DATE: October 29, 1998
PROJ. #: 346433.04
SUBJECT: Addendum Work Plan
Chevron #9-3322
7225 Bancroft Avenue
Oakland, California

Subject: Addendum To Work Plan For Monitoring Well Installation At Chevron Station #9-3322, 7225 Bancroft Avenue, Oakland, California.

WELL CONSTRUCTION DETAIL

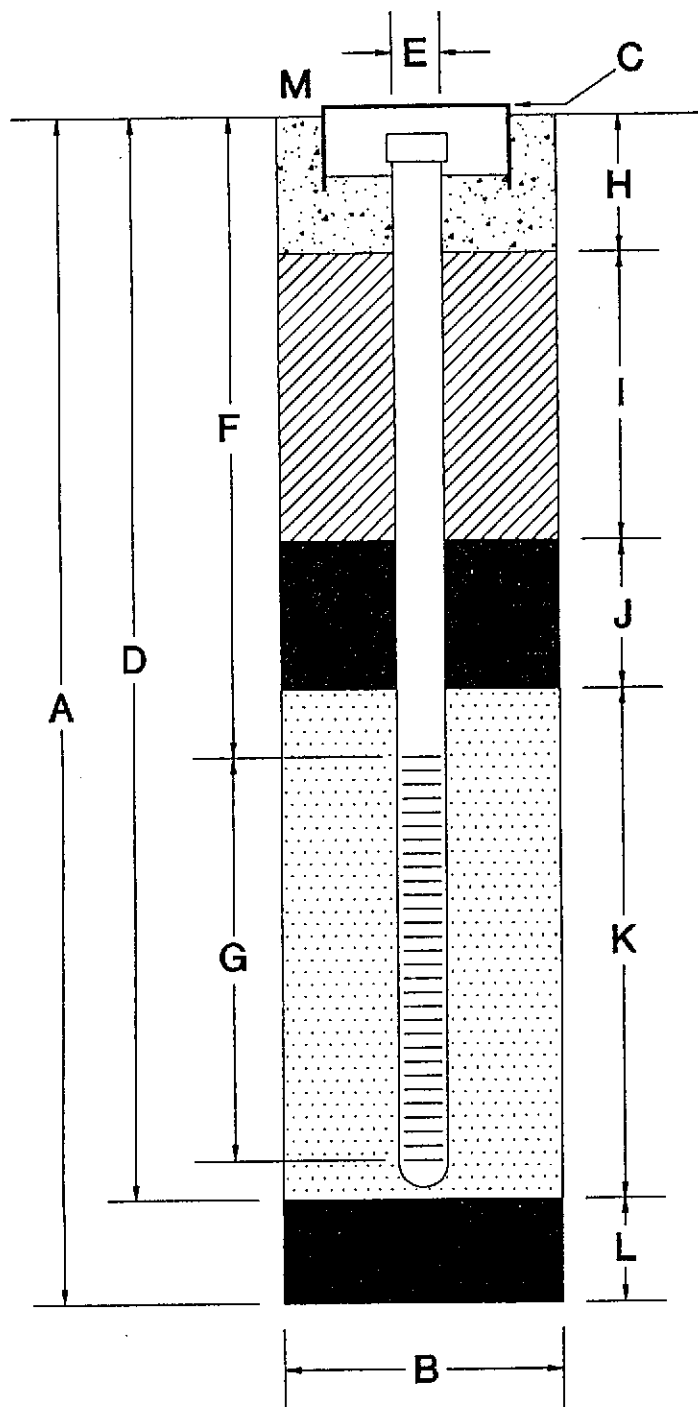
The three groundwater monitoring wells will be constructed with 25 feet of schedule 40 PVC well casing and 15 feet (10 to 25 feet bgs) of 0.02-inch machine slotted well screen as shown in the revised Well Construction Details (attached). **Actual screen intervals will depend on the groundwater depth and lithologic conditions encountered during drilling.**

- A Total Depth Of Boring 25 ft.
- B Diameter Of Boring 8 in.
Drilling Method HOLLOW-STEM AUGER
- C Top Of Box Elevation _____ ft.
 Referenced To Mean Sea Level
 Referenced To Project Datum
- D Casing Length 25 ft.
Material Schedule 40 PVC
- E Casing Diameter 2 in.
- F Depth To Top Perforations 10 ft.
- G Perforated Length 15 ft.
Perforated Interval From 10 to 25 ft.
Perforation Type Machine-slotted
Perforation Size 0.02 in.
- H Surface Seal From 0 to 1.0 ft.
Seal Material Concrete
- I Backfill From 1.0 to 6.0 ft.
Backfill Material Neat Cement
- J Seal From 6.0 to 8.0 ft.
Seal Material Bentonite
- K Gravel Pack From 8.0 to 25 ft.
Pack Material Lonestar #3 Sand
- L Bottom Seal None ft.
Seal Material _____
- M Traffic rated vault box, locking well cap and lock.
